CAA Operational Assessment

Title of airspace change proposal	Llanbedr Danger Area
Change sponsor	Snowdonia Aerospace LLP
Project no.	ACP-2019-58
Account Manager	[REDACTED]
<i>Case study commencement date</i>	15/02/21
<i>Case study report as at</i>	17/05/21
<p><i>Instructions</i></p> <p>In providing a response for each question, please ensure that the ‘status’ column is completed using the following options:</p> <ul style="list-style-type: none"> • yes • no • partially • n/a <p>To aid the SARG project leader’s efficient project management it may be useful that each question is also highlighted accordingly to illustrate what is:</p> <p>resolved Green not resolved Amber not compliant ...Red...</p>

Executive Summary

Option 1

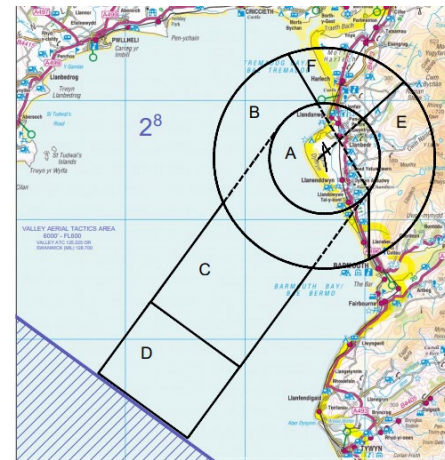
Post consultation, it was determined that Option 1 was the clearer to understand, whereas Option 2 provided more flexibility for activation and limiting impact to other users.

Option 2B

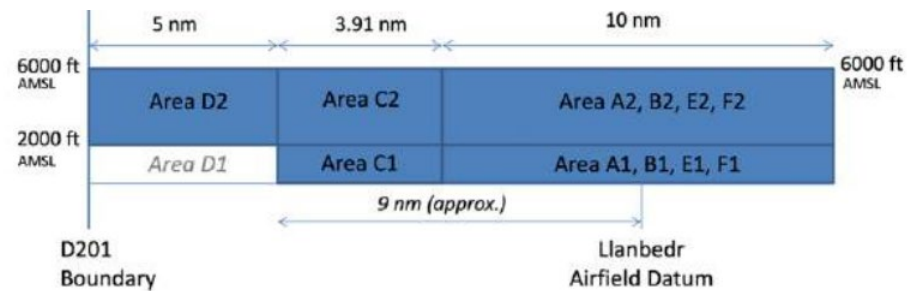
Post engagement Option 2B has been proposed. This proposal made two adjustments from the Option 2 design:

- An adjustment of the internal divide of sectors E&F in response to the high ground to the east of the airfield and enabling a route for GA to transit.
- An extension of area D from 4nm to 5nm in length. Area D is not contiguous with the sea but instead starts at 2,000ft AMSL, Area D1 above is not a DA but has been named by the sponsor within the diagram to support identification and discussion within the document to identify the gap under D2, whereas area C starts from sea level. This effectively forms a tunnel for aircraft to transit between Area C and D201. The extension of the area from 4 to 5nm was to increase this separation and reduce the funnelling effect.

The amendments reflect changes to option 2 which are logical and follow from the consultation. The design is however complex where this complexity is driven by the location of the surrounding high ground, surrounding traffic considerations and the limited capabilities of Llanbedr in not being able to provide a DACS due to the type of ATS provide from the aerodrome.

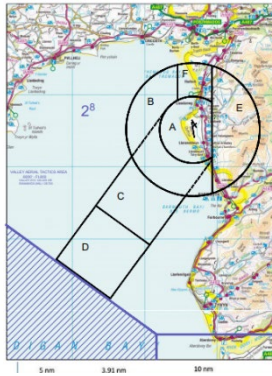
2.5	Is the analysis of the impact of the traffic mix on complexity and workload of operations complete and satisfactory?	Not resolved
	<p>This ACP is creating ‘segregated airspace’ which reduces the mixing of traffic at Llanbedr but will have external associated impact as well as potentially increasing overall workload. A safety assessment has been conducted on how the change would affect Llanbedr operations and an ATM assessment which includes the incorporation of the mitigations outlined within the Safety Assessment.</p> <p>Within the risk assessment ‘Funnelling of GA traffic in conflict with military traffic’ remains Amber post mitigations. The specific mitigations to address this point was increasing the length of Area D and redesigning Area E and minimising its activation.</p> <p>Recommended Condition A suggested limitation on E activation was allied in the proposal to not activating B and F. No limitation was proposed linking Area E and Area C activations. Considering the diagram below it can be seen if Area C was activated when Area E was activated concurrently, this would be more significant than if area B and/or F were activated concurrently with Area E. Noting the lack of DACS this could potentially result in a significant re-route and funnelling of traffic underneath Area D (element D1 in diagram in section 1.4 above).</p> <p>A proposal to satisfy this section should be to apply the same pre-condition that Area C could not be activated when Area E was activated. This should have minimum impact as the type of operations planned to be conducted in Area E differ from those described in Area C.</p> <p>Similarly, a condition should be placed that ensures Area B cannot be activated at the same time as Area E. [see Condition 4, page 21]</p>
